**BOARD OF ZONING ADJUSTMENT
STAFF REPORT****Date: February 3, 2014****CASE NUMBER**

5876/4812/4709

Jerry Ward

LOCATION1981 St. Stephens Road
(Northwest corner of St. Stephens Road and St. Stephens Court)**VARIANCE REQUEST****USE:** To allow a 2,251 square-foot restaurant and a car wash in an R-1, Single-Family Residential District.**PARKING RATIO:** To allow 8 parking spaces.**ACCESS/MANEUVERING:** To allow sub-standard access and maneuvering areas.**TREE AND LANDSCAPE:** To allow no tree plantings or landscaped area.**SIDE AND REAR SETBACK:** To allow a structure 6' ± from the side street side yard property line and within 6' ± of the rear property line.**ZONING ORDINANCE
REQUIREMENT****USE:** The Zoning Ordinance requires a minimum of a B-2, Neighborhood Business District to allow a restaurant and carwash.**PARKING RATIO:** The Zoning Ordinance requires 23 parking spaces.**ACCESS/MANEUVERING:** The Zoning Ordinance requires a 12' wide access aisle for one-way traffic.**TREE AND LANDSCAPE:** The Zoning Ordinance requires full compliance with tree planting and landscaped areas.**SIDE AND REAR SETBACK:** The Zoning Ordinance requires all structures be a minimum of 20' from a sid

SITE PLAN

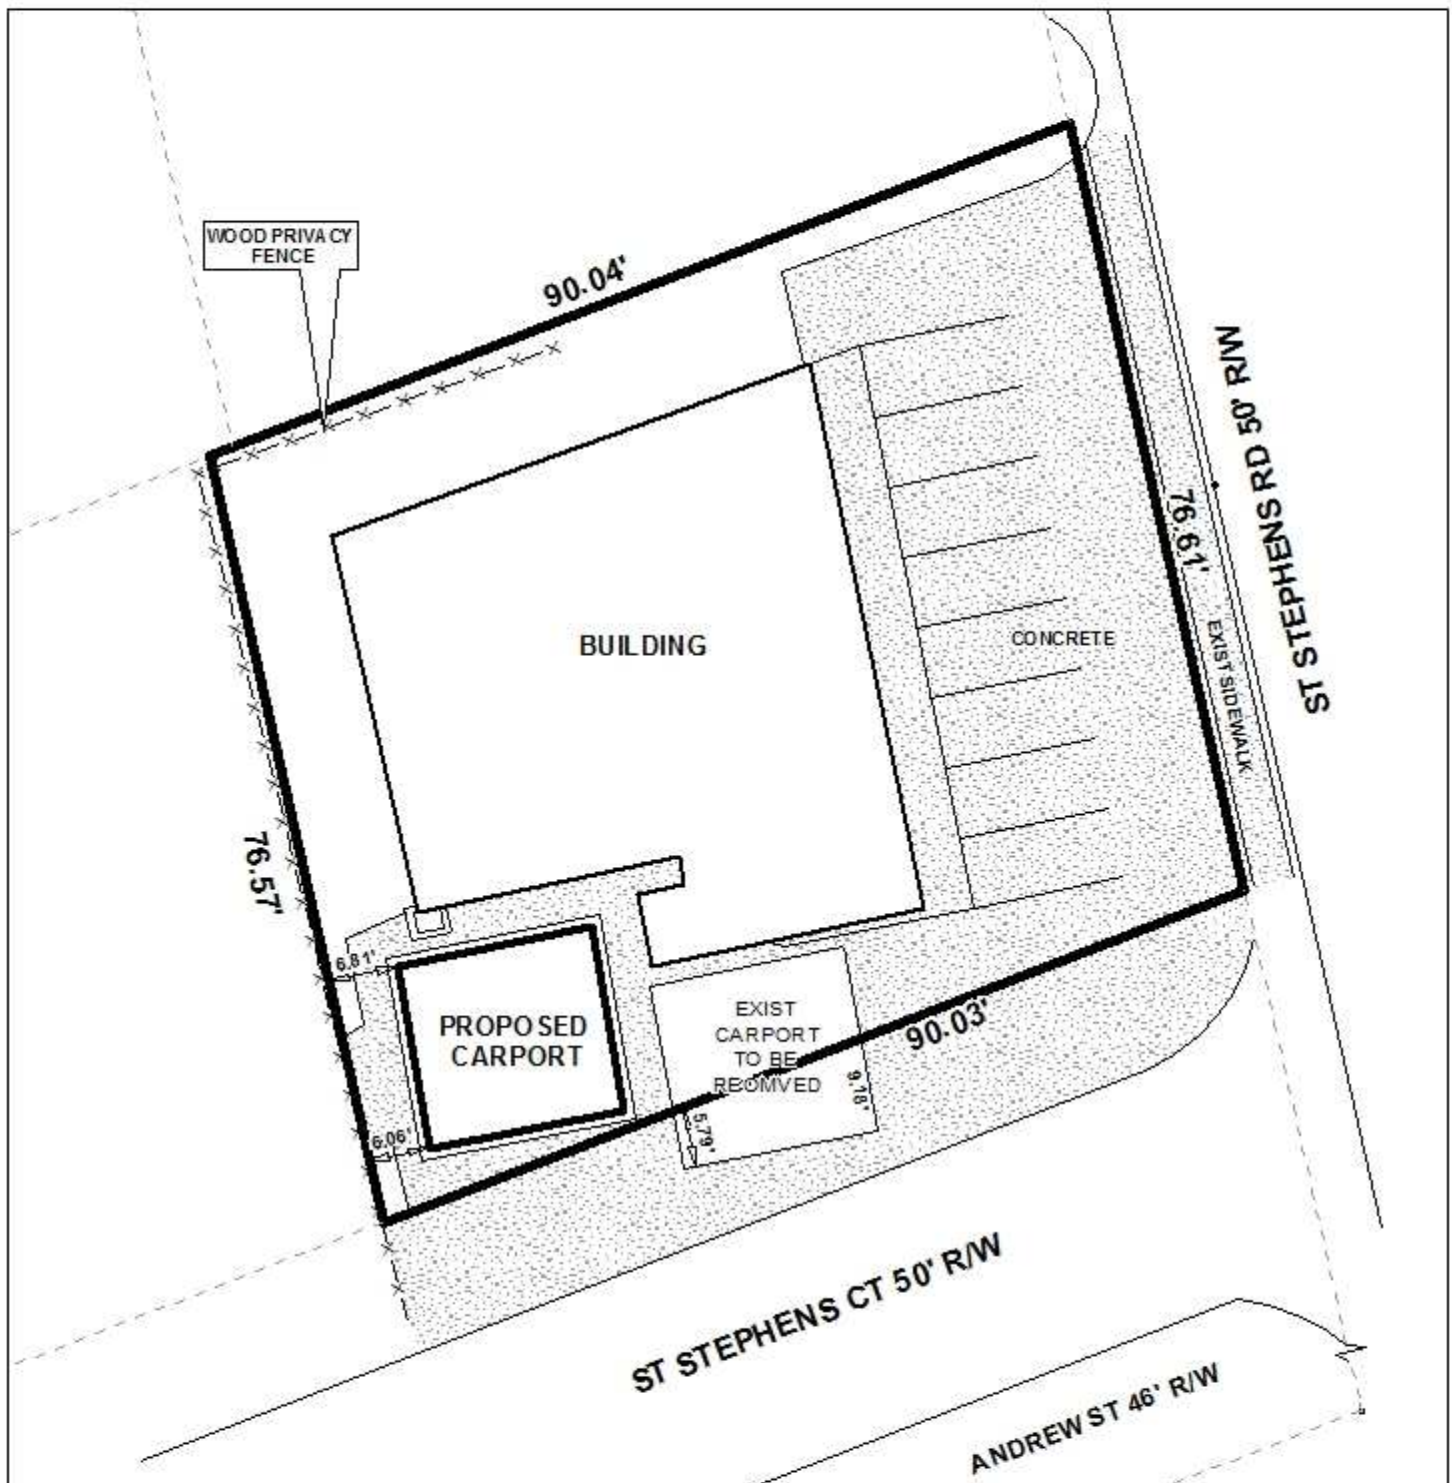
The parking spaces illustrated are only 7' wide, two feet less than the 9' city standard width. The spaces are also only 15' deep, three feet less than the 18' city standard depth. If striped parking is required, angled parking is suggested, with the "driveway" north of the power pole designated as the entrance, and the "driveway" south of the power pole designated as the exit. This should minimize the impact of vehicles backing and maneuvering in the right of way. (Site plan does not illustrate small grassed area surrounding power pole.).

In reference to the Parking Ratio Variance request, the restaurant use requires 23 parking spaces; however, as the site is already developed and due to its size and layout, the applicant proposes only 8 substandard parking spaces, 15 short of the required number of spaces. It should be pointed out that the site plan depicts the proposed spaces with a dimension of only 7' x 15' and the applicant has not requested an additional variance for the substandard dimensions of the proposed parking spaces. If the carwash use is discontinued and the unpermitted structure

removed, the applicant may be able to accommodate 2 or 3 additional parking spaces on the south side of the property where the carwash structure is located. It should be pointed out that the site plan does not illustrate any handicapped parking.

Finally, in reference to the Side and Rear Setback Variance, the proposed relocation of the carwash would place it entirely on the property, outside of the right-of-way for St. Stephens Court; however, it would still be within the required side street and rear yard setbacks of 20 feet and 10 feet, respectively. While this would be an improvement over existing conditions, it would still be problematic.

It should be pointed out that the site plan does not illustrate the location of a dumpster or a note referencing curb-side pickup. Use of a dumpster will require the construction of a dumpster pad with enclosure connected to sanitary sewer, and the location of the pad must meet all side and rear yard setbacks. The site plan should be revised to illustrate the location of a dumpster in

- 3) Hours limited to 7am-10pm; and
- 4) Provision of appropriate waste disposal and revision of the site plan to illustrate the location of a dumpster in compliance with Section 64-4.D.9. of the Zoning Ordinance, or depict a note stating that garbage will be collected via curb-side pickup.

- 1) Revision of the site plan to depict compliant angled or 90° parking; 9'x18' spaces;
- 2) Revision of the site plan to depict compliant parking along the southern side of the building;

- 4) Provide one "van accessible" compliant space with access aisle and revision of the site plan to illustrate a handicapped parking space compliant with the Americans with Disabilities act.
